Nine 2 Nine Intimates Ltd

35/A –B, Kalurghat Heavy Industrial Area ,Chittagong 4208 , Bangladesh
(22.390795, 91.872791)

18 June 2017

Observations

Observations: Main Building

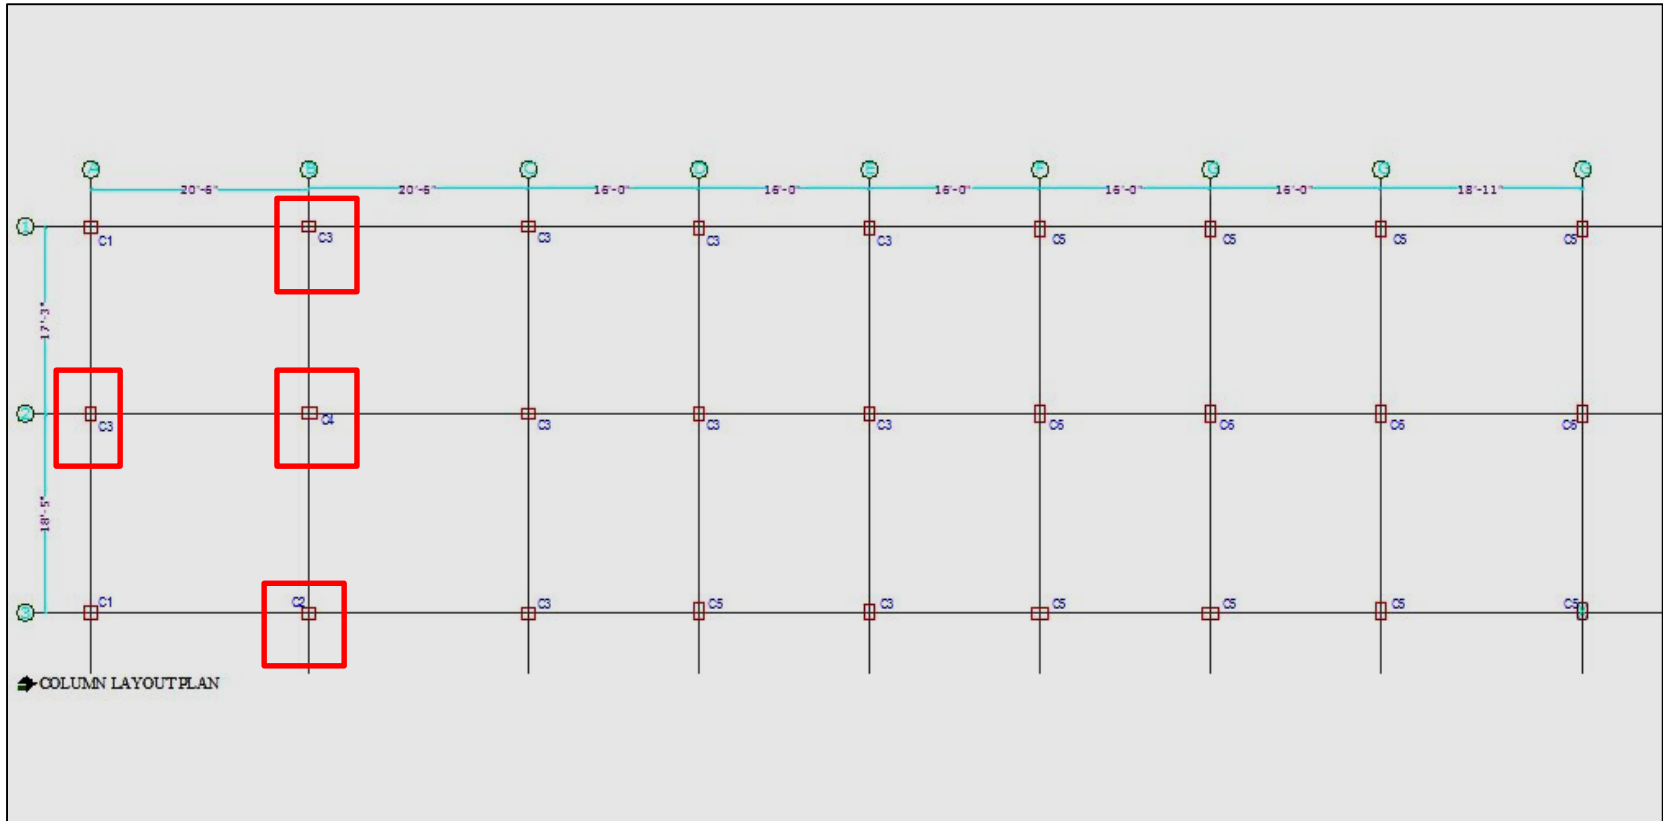
Foundation of main Building exceeds normal design limit

According to the design report Factor Of Safety of some of the foundations are found less than the recommended $FOS=2.5$ as per BNBC (marked below). It creates concern of the capacity of the pile foundation. Building engineer is required to check the capacity of the foundation system as part of the Engineering Assessment.

Observations: Generator Building

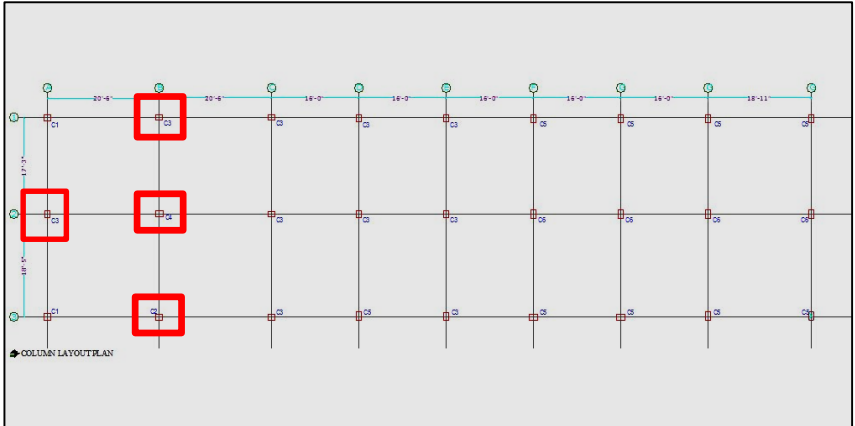
Mismatch was found in the column size in the marked location. Factory is required to update the structural drawing as per the as built condition.

Observations: Generator Building

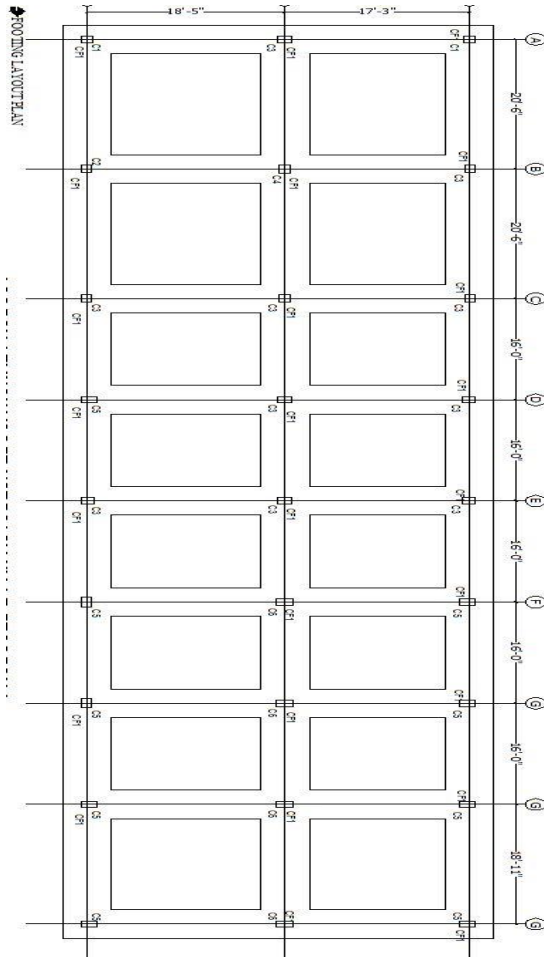
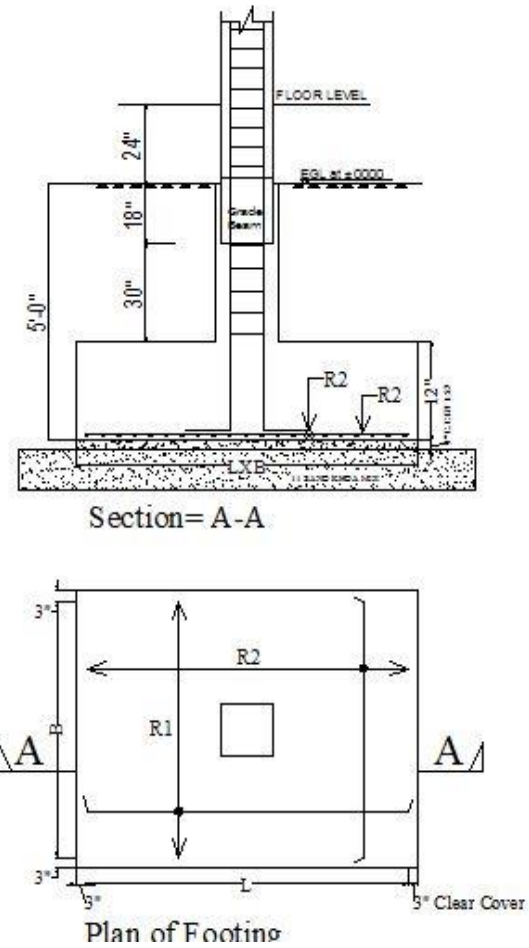
For example in the marked location (Grid A2) the column size was mentioned to have 300mmx375mm. In as built condition the section was found 350mmx375mm. Also in Grid B2 column size was found 300mmx 450mm instead of mentioned 325mmx 400mm . In Grid B1 size was found 300mmx450mm instead of 300mm x375mm and in Grid B3 the found size was 300mmx450mm instead of 300mmx375mm.

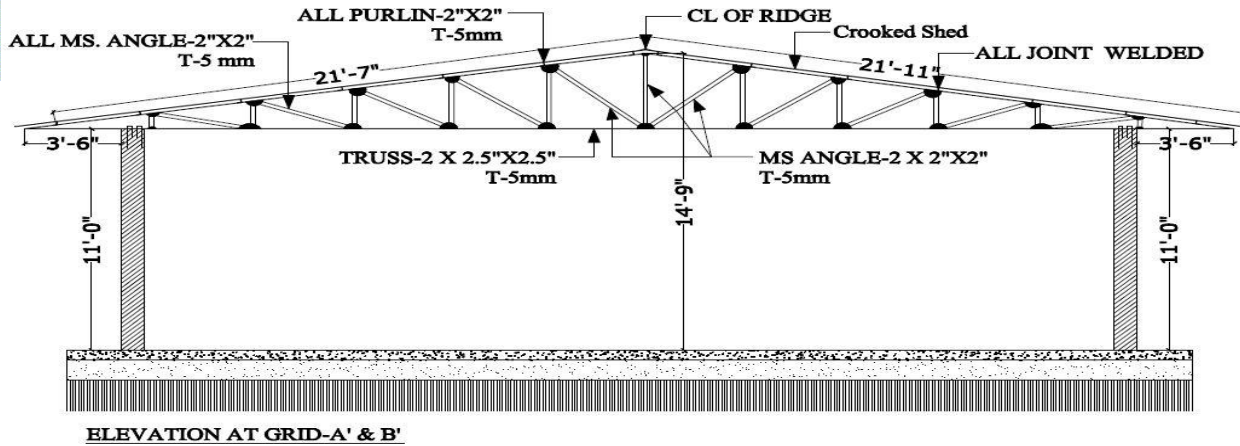
Foundation layout shows strip foundation

Section & plan of footing shows isolated column footing

Mismatch between footing layout and section & footing plan has been found. Design report has also stated that the footing type is isolated column footing which leads to ambiguity regarding existing footing.

Factory engineer is required to investigate the foundation type of the building.

Observations: Generator Building

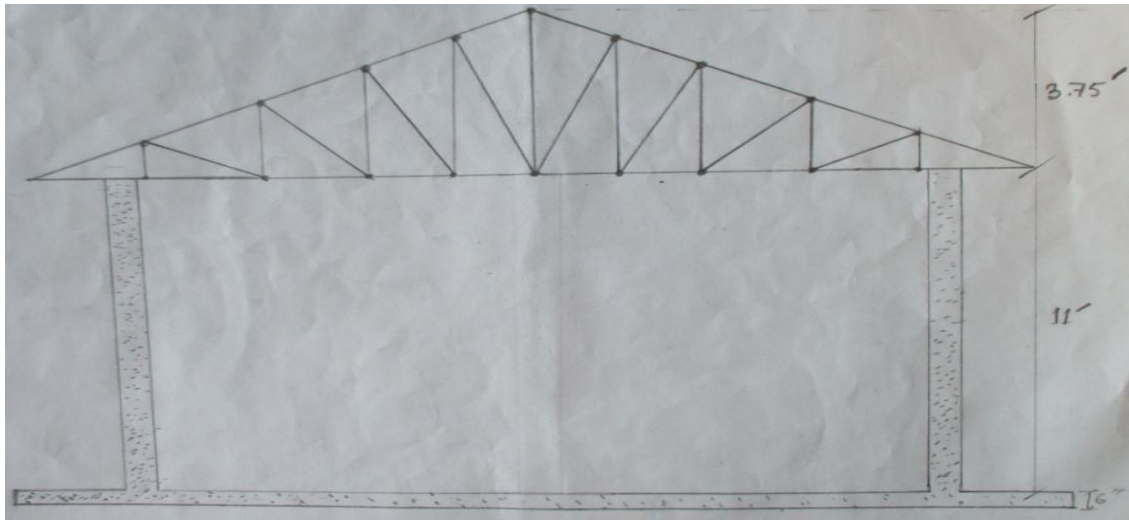
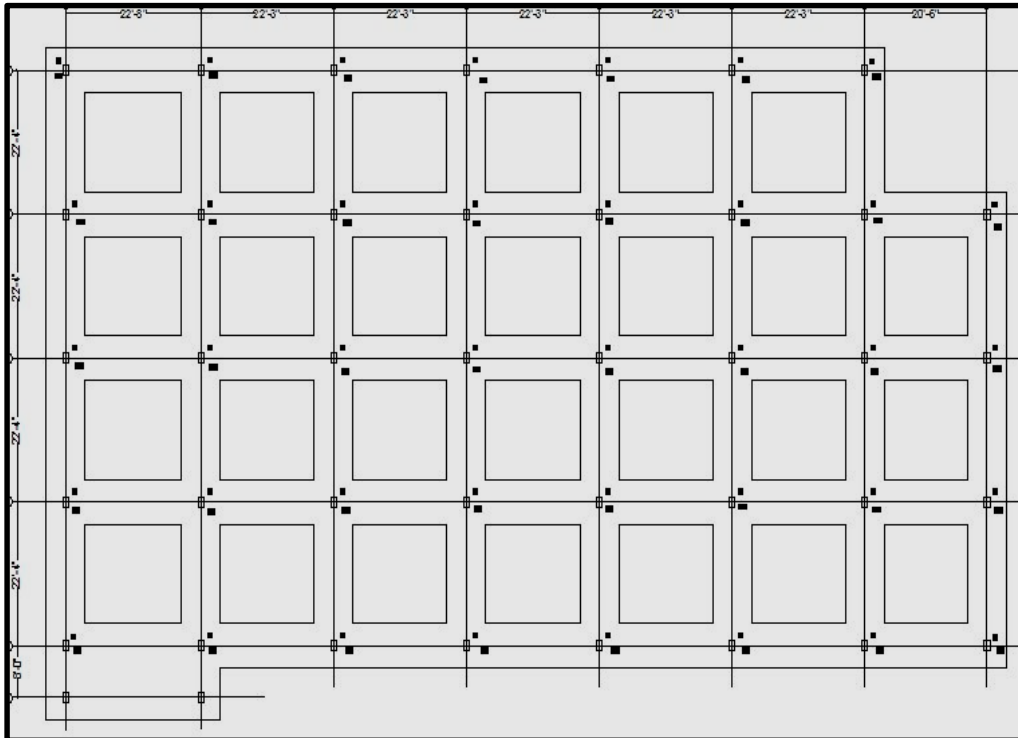
Provided Drawing of Truss: Number of vertical members are 11

Existing Truss: Number of vertical members are 9

Mismatch between existing Trusses of roof top Shed & provided drawing has been found.

Factory engineer is required to update the as built drawing . Also adequacy check is required to verify.

Mismatch in footing layout

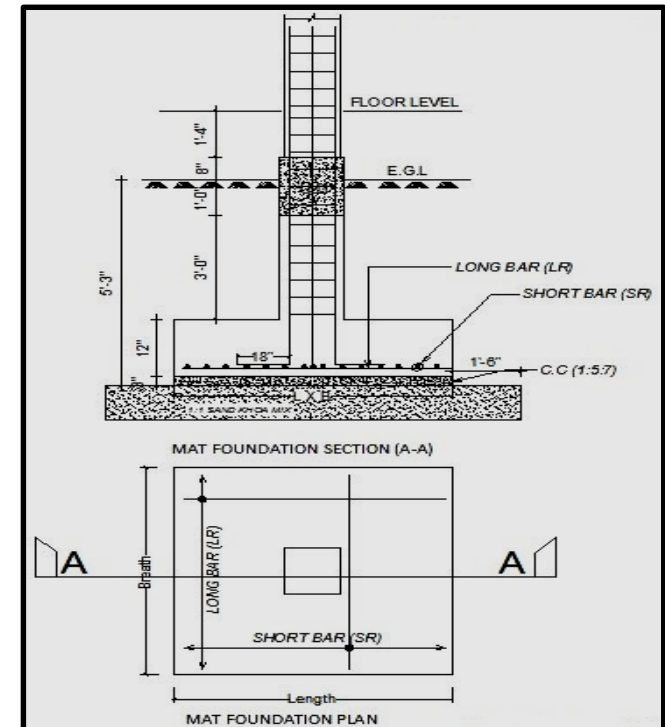
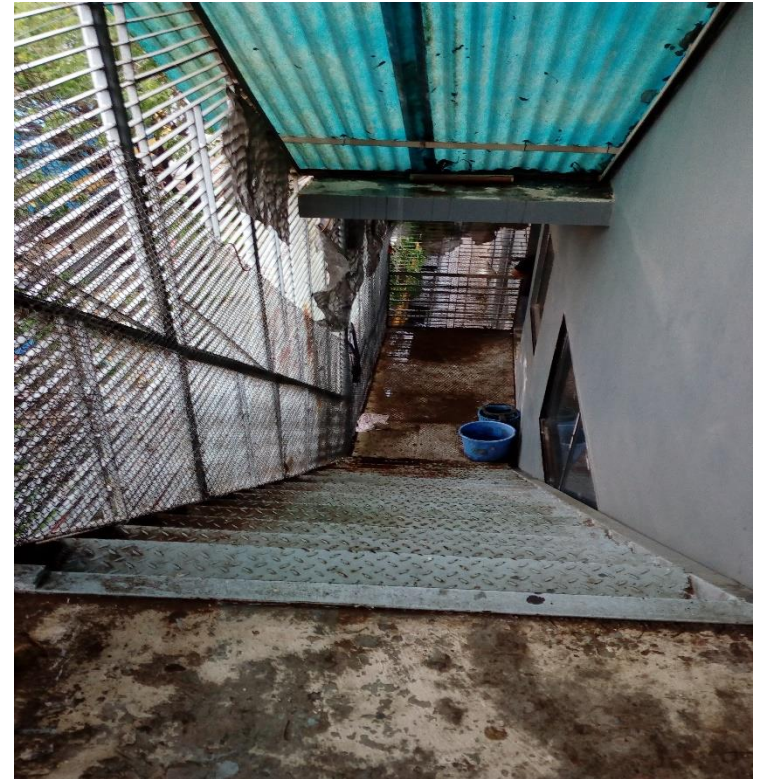
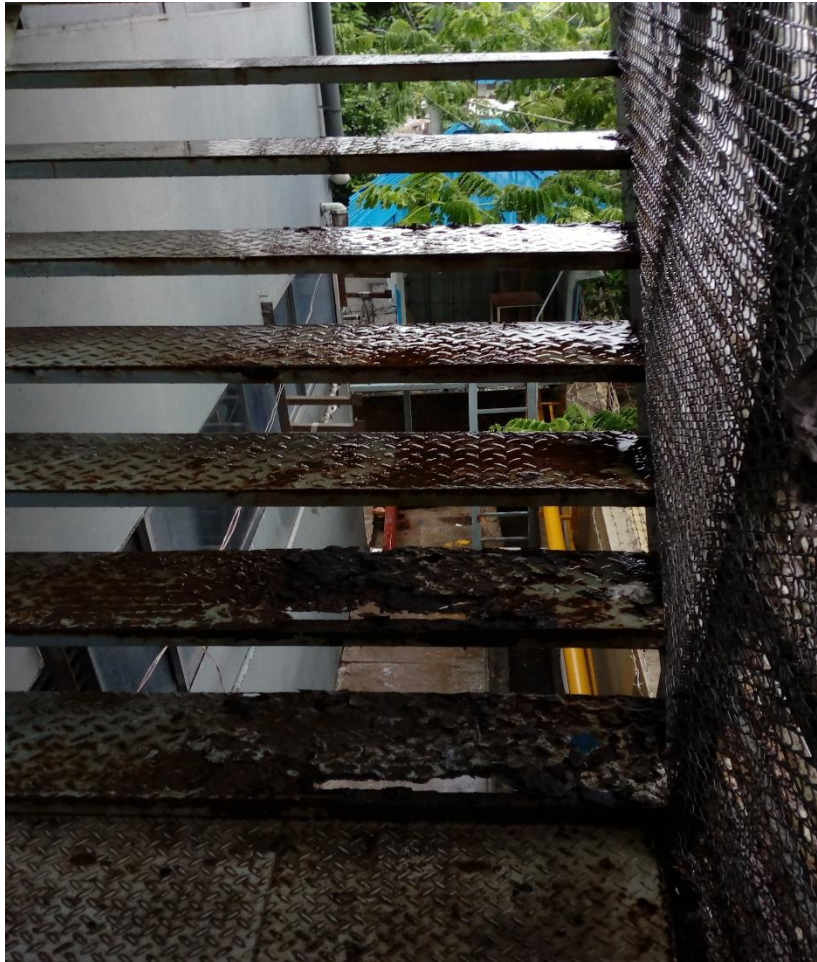
Mismatch between footing layout and section & footing plan has been found. Design report has also stated that the footing type is isolated column footing which leads to ambiguity regarding existing footing. Factory engineer is required to investigate the foundation type of the building.

Foundation layout shows strip foundation

Section & plan of footing shows isolated column footing
